## REQUEST FOR BOARD ACTION

**SUBJECT:** Revised Master and Phase II Development Plan Couch Mountain (Formerly Luna Ridge) Major Subdivision (2019-M03)

**Henderson County Planning Department Staff Report**

**Combined Revised Master and Phase II Development Plan  
Couch Mountain Major Residential Subdivision (2019-M03)**

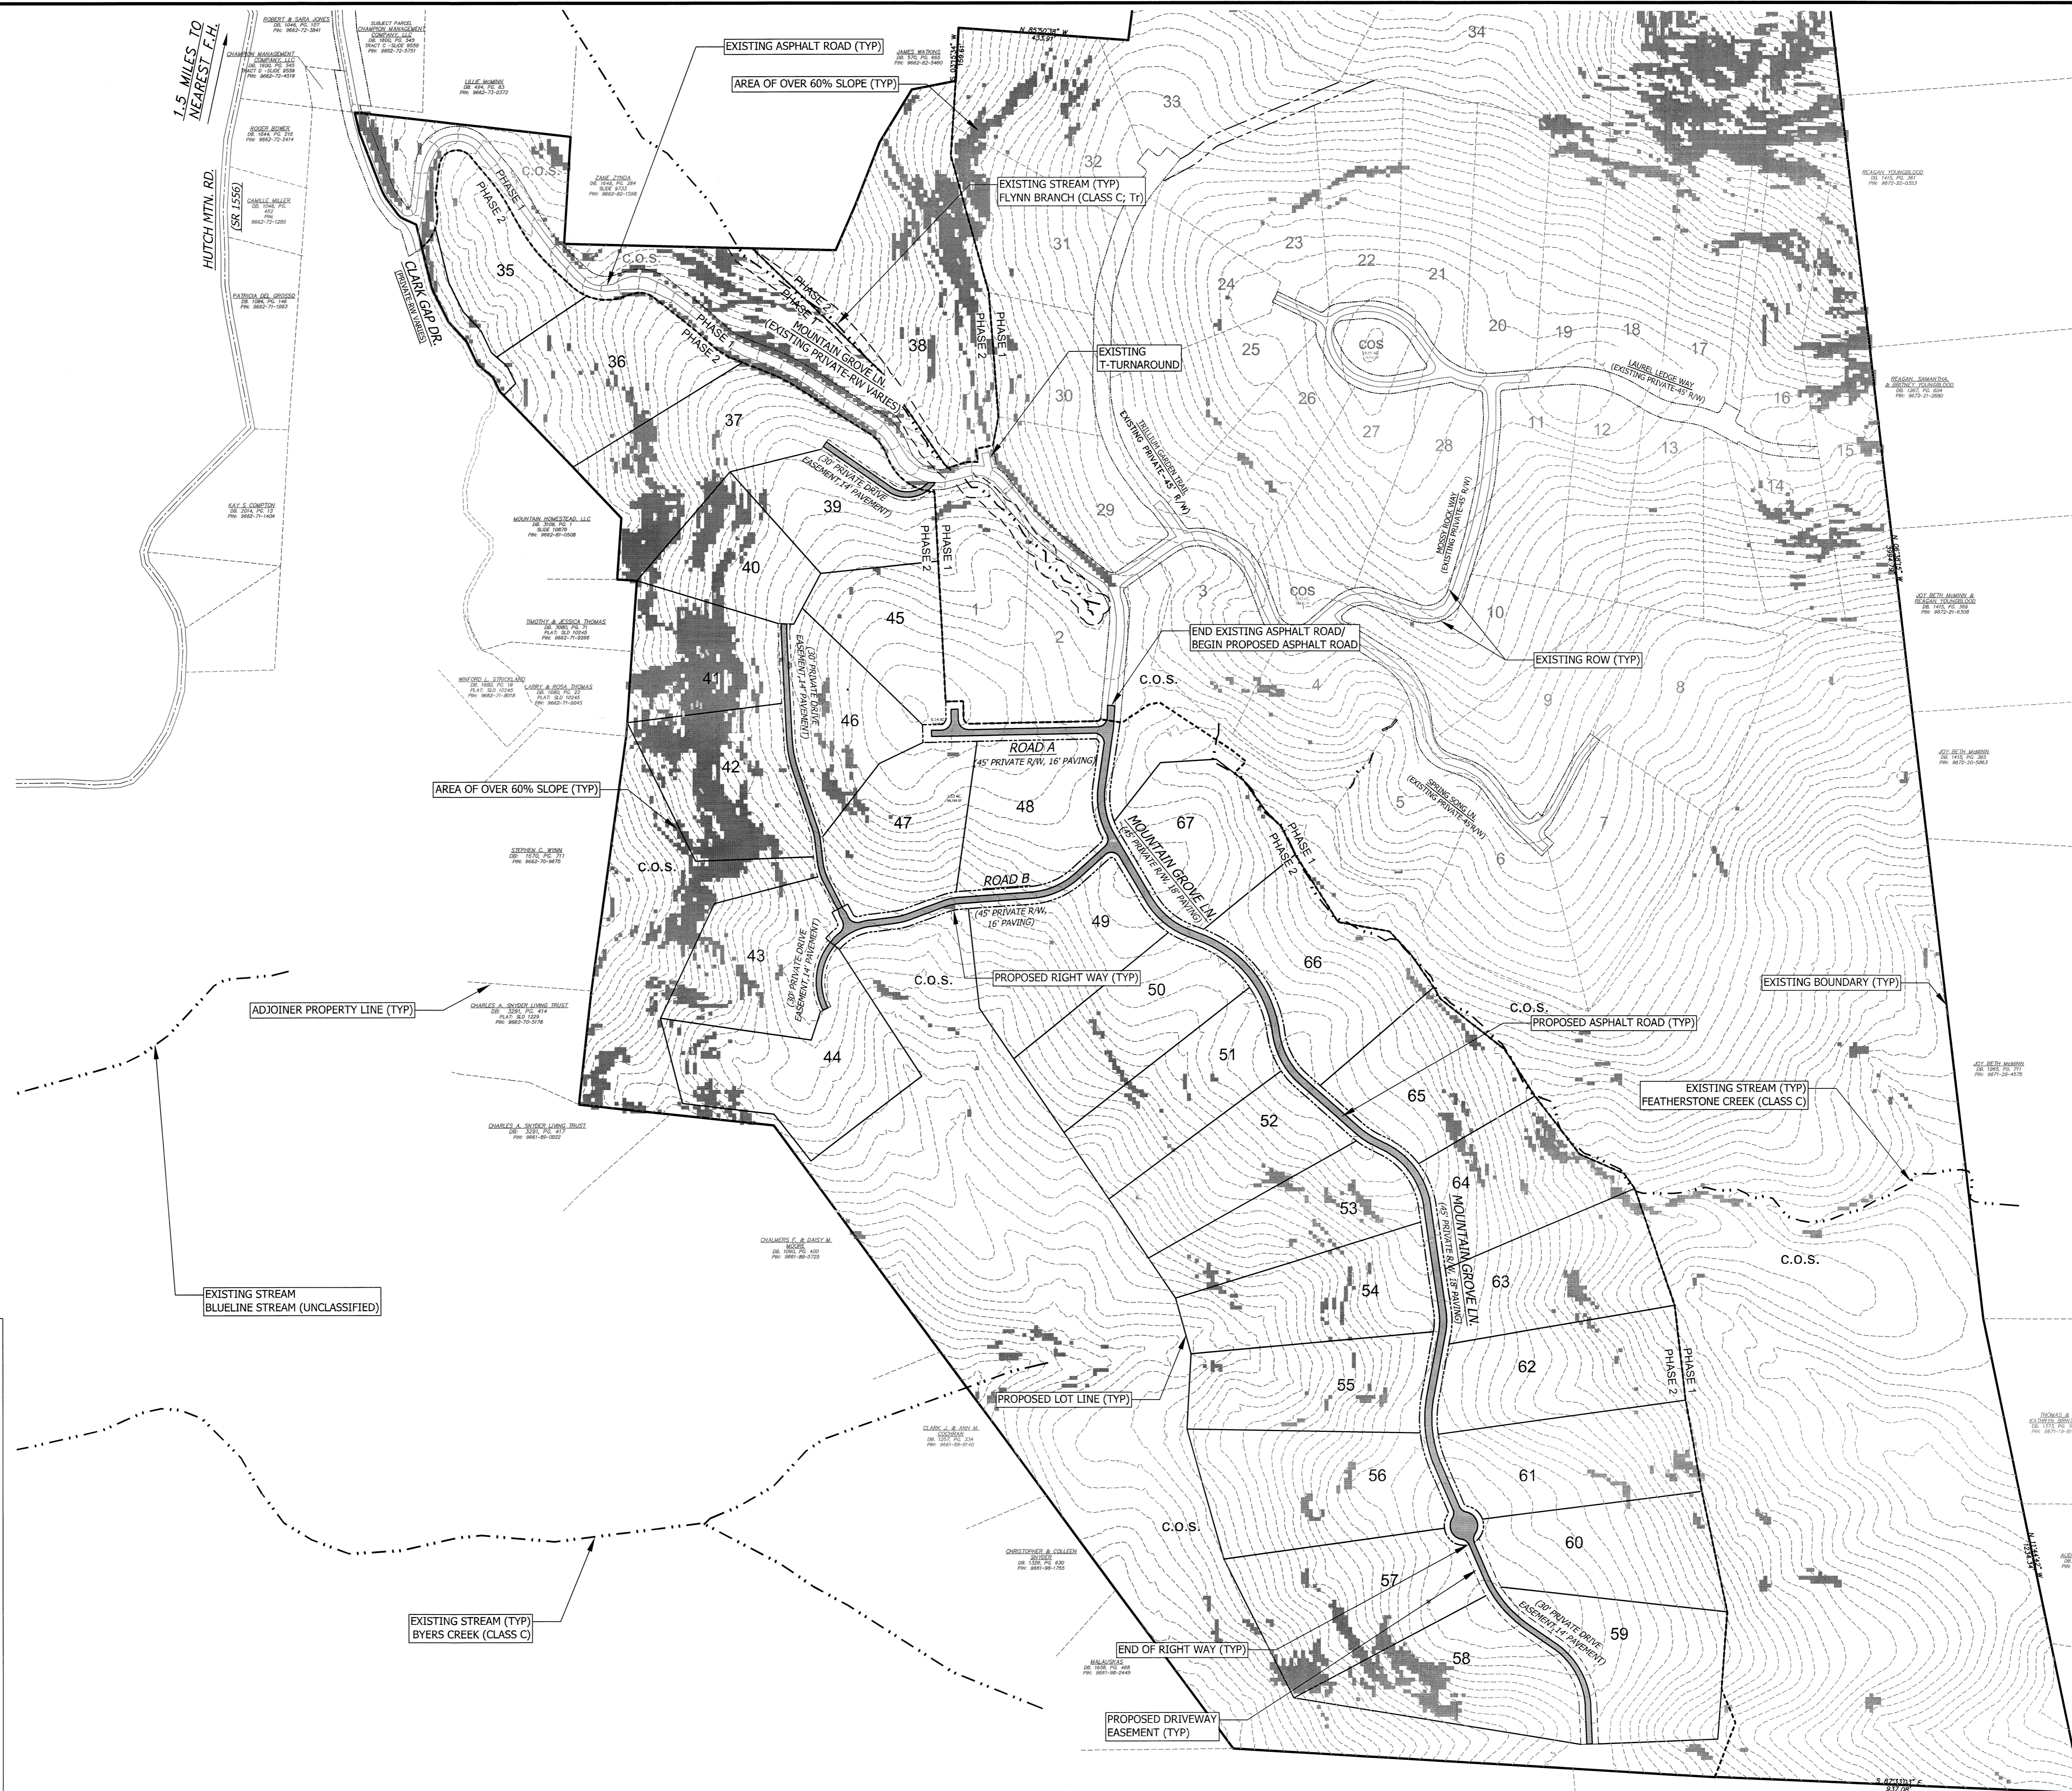
1. **Soil Erosion and Sedimentation Control Plan.** The Applicant shall submit written notice from the appropriate local agencies verifying that an Erosion and Sedimentation Control Plan has been received or a written notice from a professional land surveyor, engineer, landscape architect, architect, or professional planner certifying that no plan is required (LDC §42-95B).

2. **Private Roads.** Private roads shall be constructed in accordance with the Private Subdivision Local Road standards stated in Chapter 42 (LDC§42-109). Additionally, subdivisions of 35 or more lots shall provide a minimum of two entrance roads. The second entrance road may be specifically waived by the approving authority where unique circumstances exist (LDC §42-95A (1)).

3. **Shoulder Stabilization.** All areas disturbed by the construction of a public road, including cut and fill slopes, shoulders and ditch banks, shall be seeded to stabilize the soil and prevent erosion. Seeding should be done as soon as feasible after road construction (LDC §42-102).

4. **Road Drainage, Culverts and Shoulder Stabilization.** Road or drainage structures shall be constructed in accordance with state roads standards. Road drainage side ditches shall be constructed with sufficient depth and width to carry the expected volume of storm water runoff (LDC §42-100). All areas disturbed by the construction of a public road, including cut and fill slopes, shoulders and ditch banks, shall be seeded to stabilize the soil and prevent erosion. Seeding should be done as soon as feasible after road construction (LDC §42-105).

5. **Road Name Approval.** Proposed road names for a private and/or public road shall be preapproved by Henderson County in accordance with Chapter 42 of the Henderson County Code, Property

Addressing (LDC §42-103). The names of the proposed roads and easements should be confirmed with the development plan approval.

6. **Road Name Signs and Regulatory Signs.** Road name signs and regulatory signs shall be provided in accordance with Chapter 142 of the Henderson County Code. Road name signs and regulatory signs must be acquired and installed prior to final plat approval (LDC §42-104).

7. **Street Tree Requirements.** According to the street tree requirements of Chapter 42 (LDC §42-95H) the applicant must provide one tree per 50 linear feet of property abutting an internal road. Trees may be placed in groups with a minimum spacing of no less than 15 feet and a maximum spacing of no more than 65 feet. The trees may be placed within the right-of-way or within 20 feet of the edge of the right-of-way. The applicant may use existing trees in accordance with LDC §42-185 instead of planting new trees. These existing trees must also be located within the right-of-way or 20 feet off the edge of the right-of-way as required by LDC §42-185.

8. **Perennial and Intermittent Surface Water Buffer.** All built-upon area shall be a minimum of 30 feet landward of all perennial and intermittent surface water, as defined in LDC §42-251.
